SR-2 – ADVISORY STAFF REPORT (03-06-2026)

ADDRESS: 2105 BURNS

APPLICATION NUMBER: HDC2026-00064

SCOPE: DEMOLISH CONTEMPORARY SUN ROOM, CONSTRUCT REAR DECK,
REHABILITATE HOUSE AND GARAGE

Photo taken by staff on 02/25/2026, Kercheval Street view

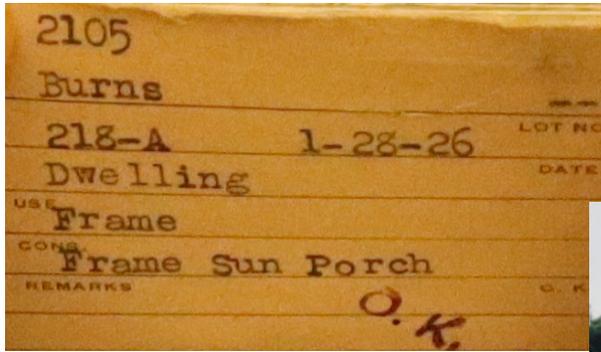
- The house is situated on the corner of Kercheval St. and Burns St., which is partially visible to the public-right-of-way. Any changes to the rear will impact on the historic character of the neighborhood.

ABOVE: Photo provided by the applicant, show the house in relation to the historic sun porch addition and the non-historic wood deck addition

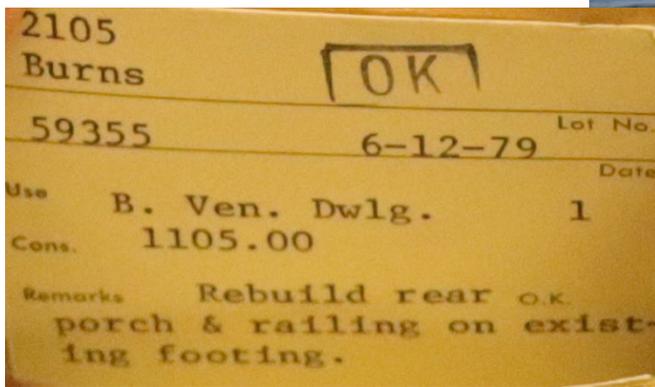
- A Building Permit Card from 1926, shows that the original sun porch at the building’s south west corner along Kercheval Street, was added to the historic house on January 28, 1926, ten years after the construction of the historic house.

- Photo slides found in the HDC records (shown above) dated May 1981, show the original 1926 sun porch (painted white) with a balcony railing.

- Staff could not find a record of review or approval for the construction of the contemporary sun room and deck, which appears to have occurred subsequent to 1981. *Photo provided by applicant of the rear wood deck*

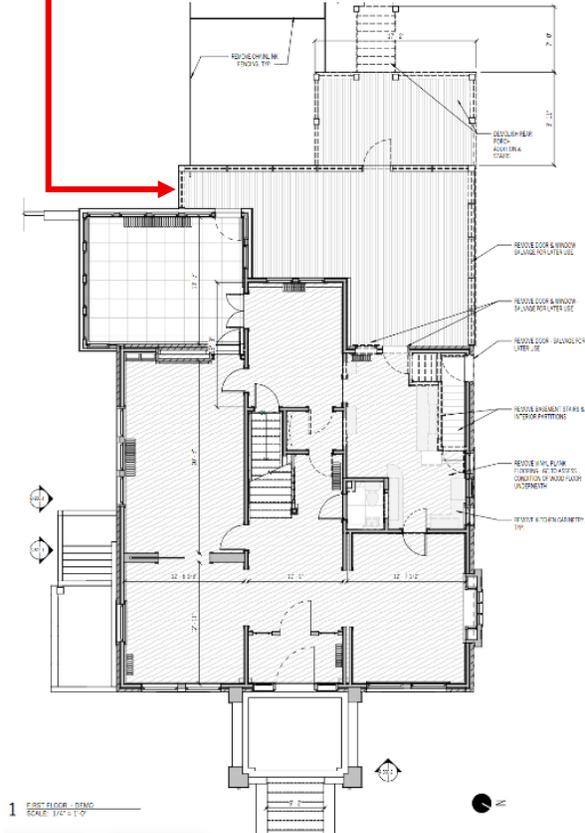
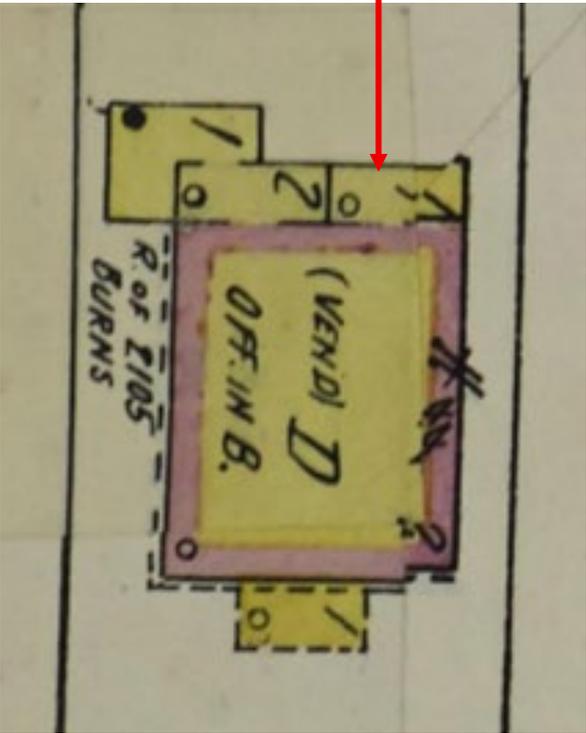
- The original 1926 sun porch has retained its overall framework and historic wood windows. However, photos provided by the applicant show evidence of unapproved work which removed a portion of the original sun porch, to make way for the existing contemporary sunroom and deck.

- Since the contemporary sunroom required the removal of the 1-story porch, no record of approval for the removal of that porch exists.
- Based on a comparison of the Sanborn Map (see below) and a demolition floor plan provided by the applicant, the contemporary sunroom addition was not part of the original house and was not added within the districts estimated period of significance.

- It is therefore staff’s opinion that the removal of the wood deck will be an appropriate demolition within the context of the historic house and will have no impact on the historic character of the building.
- It is Staff’s opinion that the proposed design for the wood deck generally appears to be compatible within the existing context and will serve as an appropriate addition to the rear of the house.
 - The contemporary design proposes a recessed lower level with larger gaps between the wooden panels which will limit visual interference with the historic house.
 - It is staffs opinion that this will improve the historic integrity of the house as it will re-expose the original brick, the character-defining door (maintaining its operability) and adjacent historic wood window, and the original sun porch.
